Date: June 6, 1979

Re: Gabriola Island Community Plan, Fault Zones

As requested by Mr. G. Tonn, Planner with the Islands Trust, a review has been undertaken of available hydrogeologic information pertaining to four "fault zones" designated in the map accompanying the Gabriola Island Community Plan (1978). These linear zones (700-foot wide strip) have been included in the community plan under Resource Protection Areas (20-acre minimum lot size), as "linear areas of rock fracture which allow surface and sub-surface water to penetrate to underground water sources known as aquifers". Available well log data, existing geology and groundwater reports and air photographs were examined in conjunction with a field visit of the area on May 30, 1979 to assess the hydrologic significance of these "fault" designated zones. For purposes of discussion the four linear zones have been arbitrarily designated areas A, B, C and D (Figure 1). A brief description of each zone is given below following a general discussion on fault terminology.

FIGURE 1.

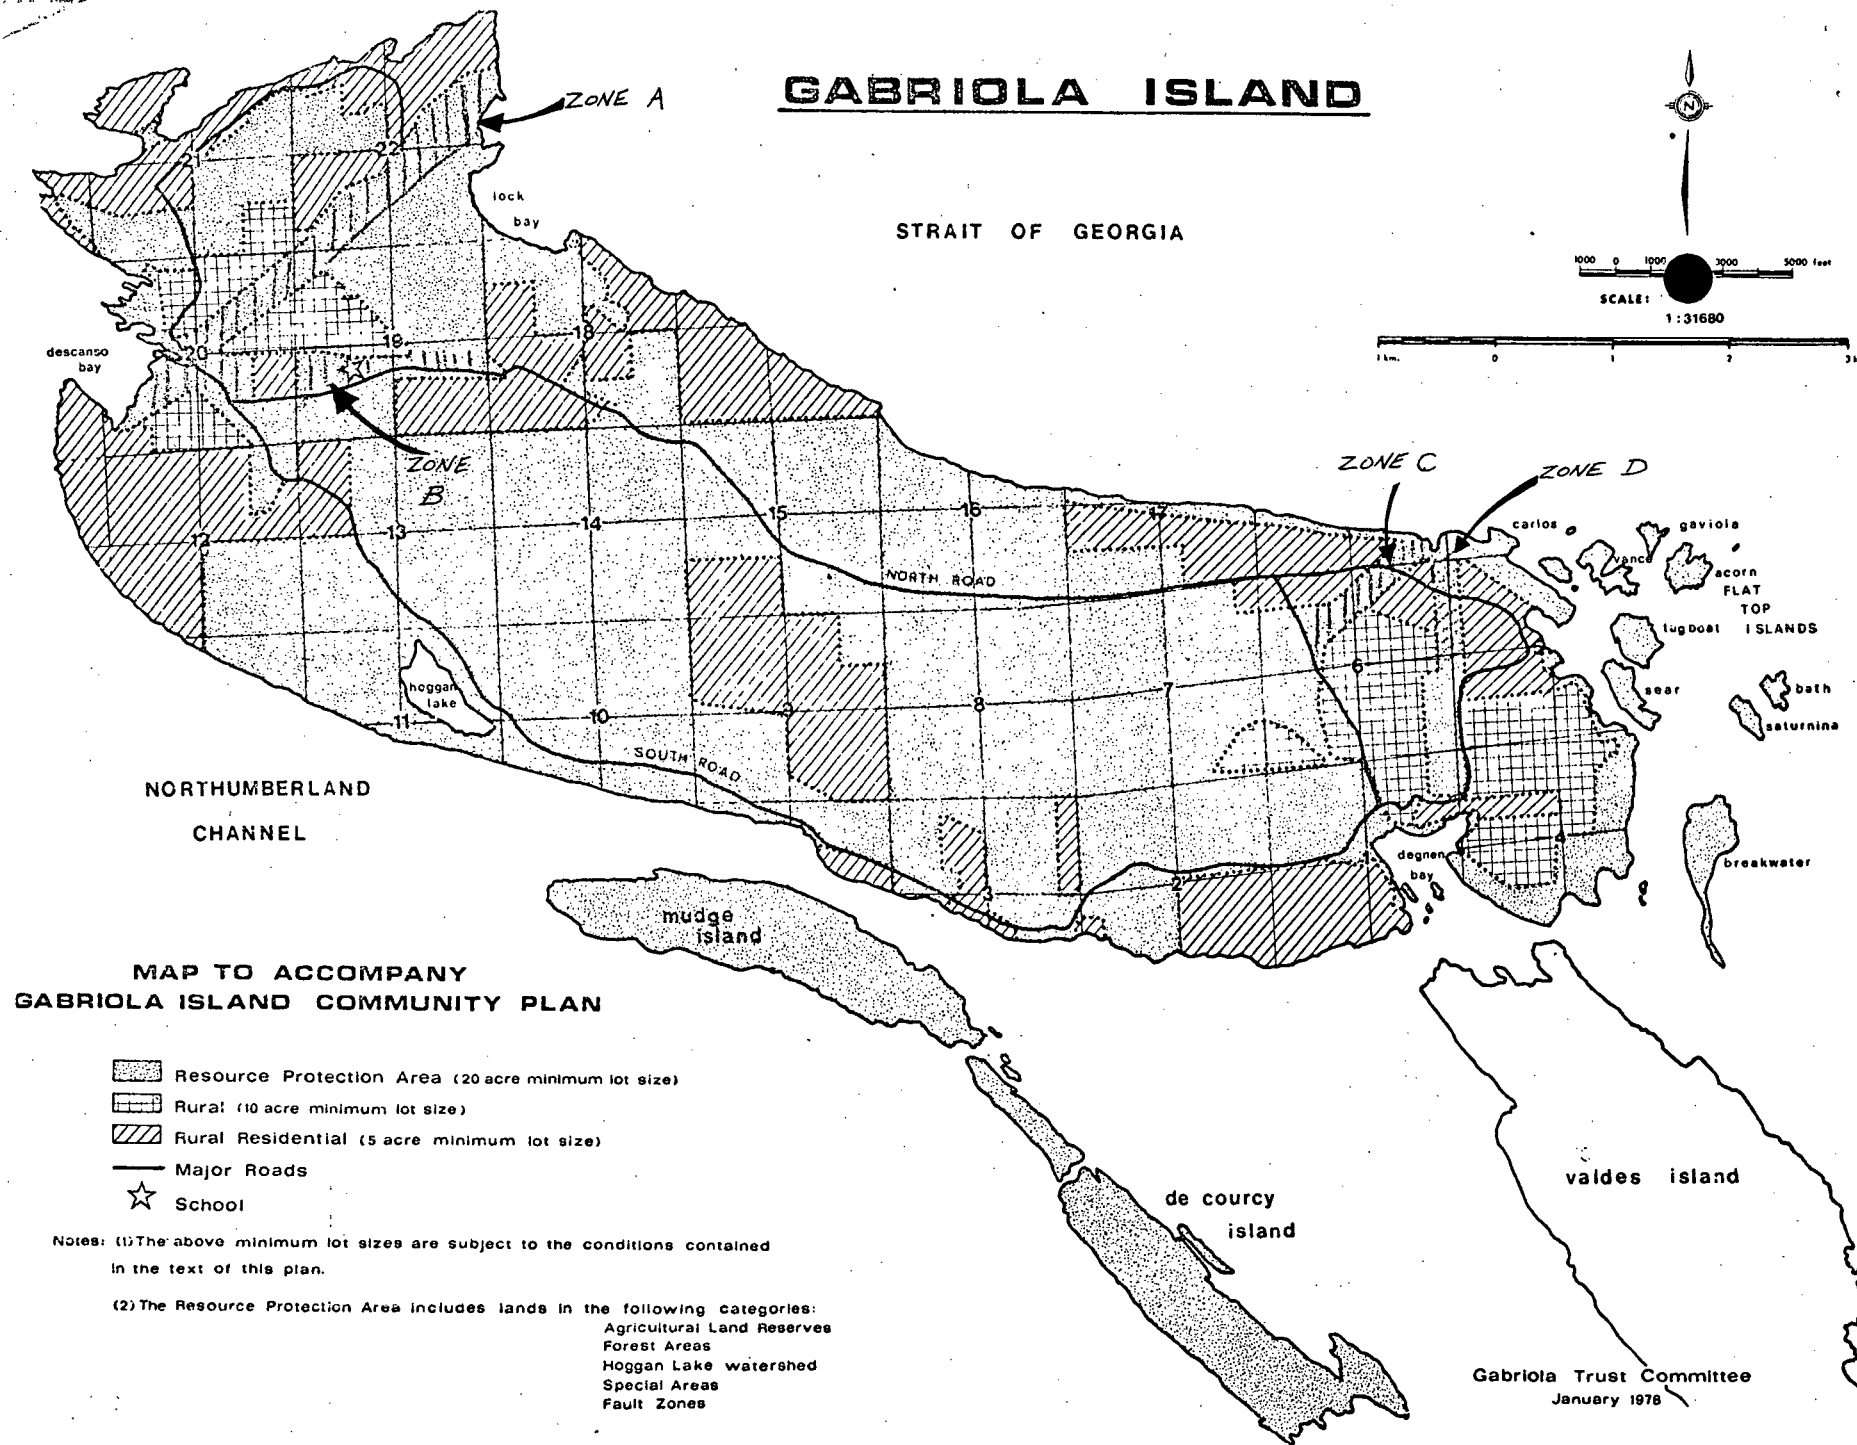
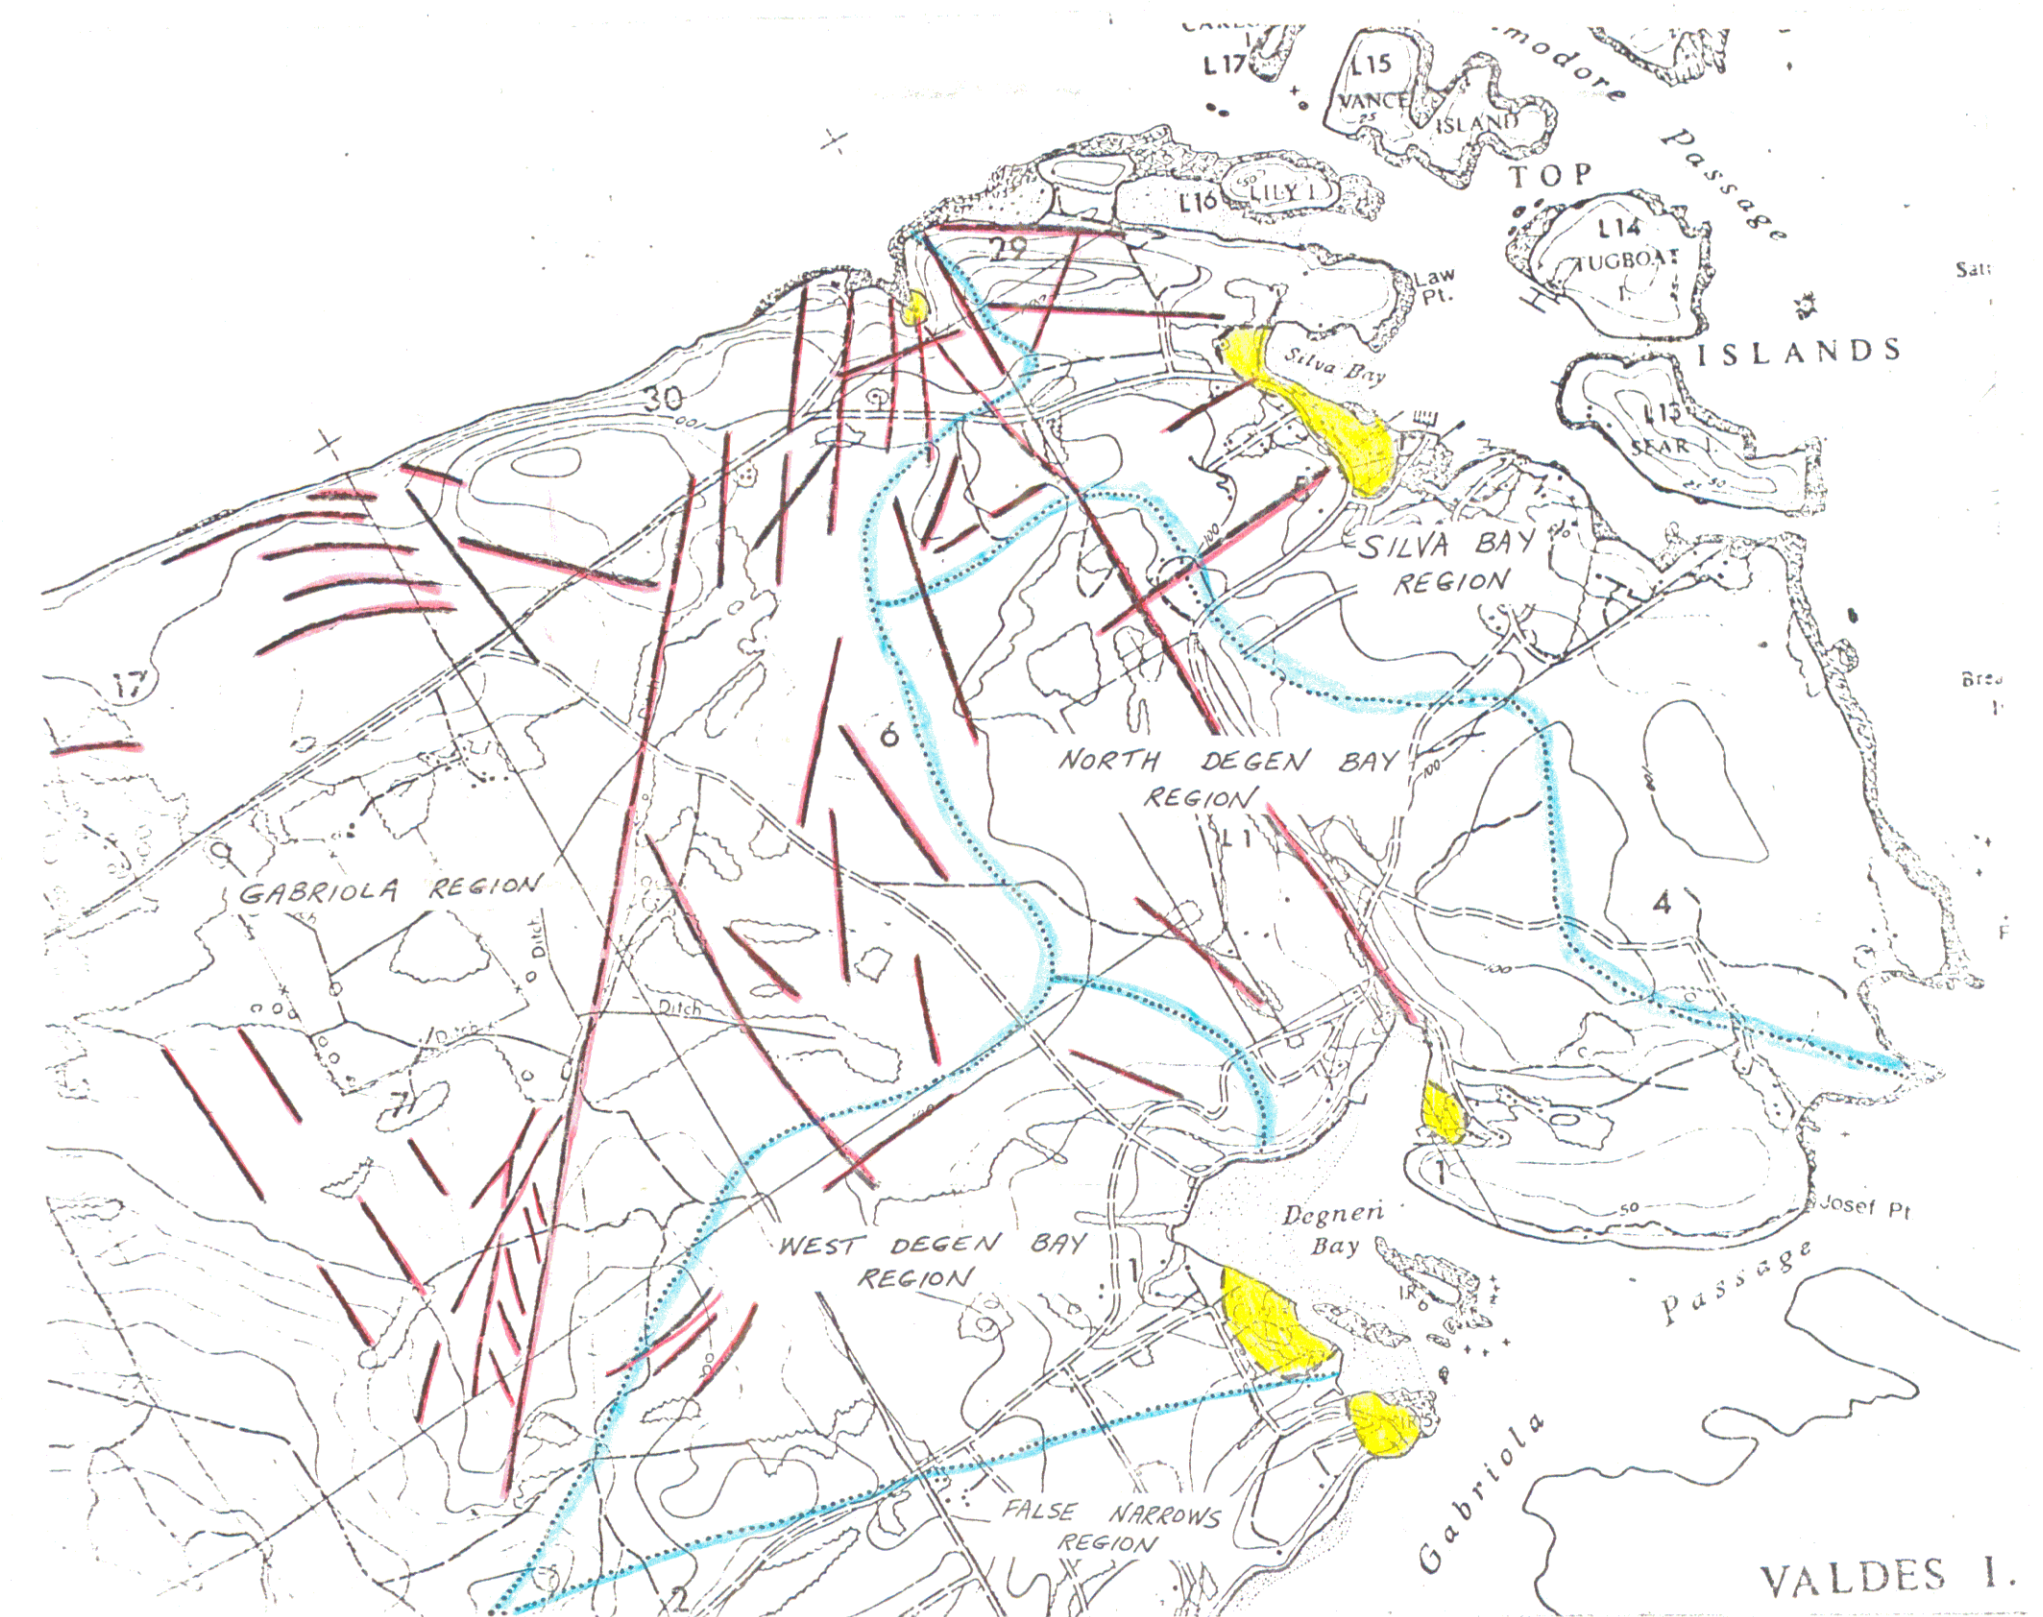
This east-west trending zone (Figure 1) lies within a major valley trend, paralleling North Road. Muller and Jeletzky (1970) indicate a major fault occurring along this trend. Several domestic wells have been drilled on properties adjacent to North Road and for the most part well yields are low. Some wells up to 212 feet deep in Section 20 adjacent to the fault zone have been reported dry. In Section 19 there is some evidence of good capacity from a deep well (greater than 200 feet in depth) on the north side of the valley. The areal distribution of water levels in existing wells suggests that groundwater recharge is taking place on the upland areas adjacent to the valley and in the upper portions of the watershed and groundwater flow is into the main valley and westerly down the topographic gradient. Local springs are evident in the valley in Section 20. In Section 19 the upper reaches of the valley above elevation 300 feet and underlain by the fault zone may be an important area of groundwater recharge, providing the fault zone is relatively permeable.
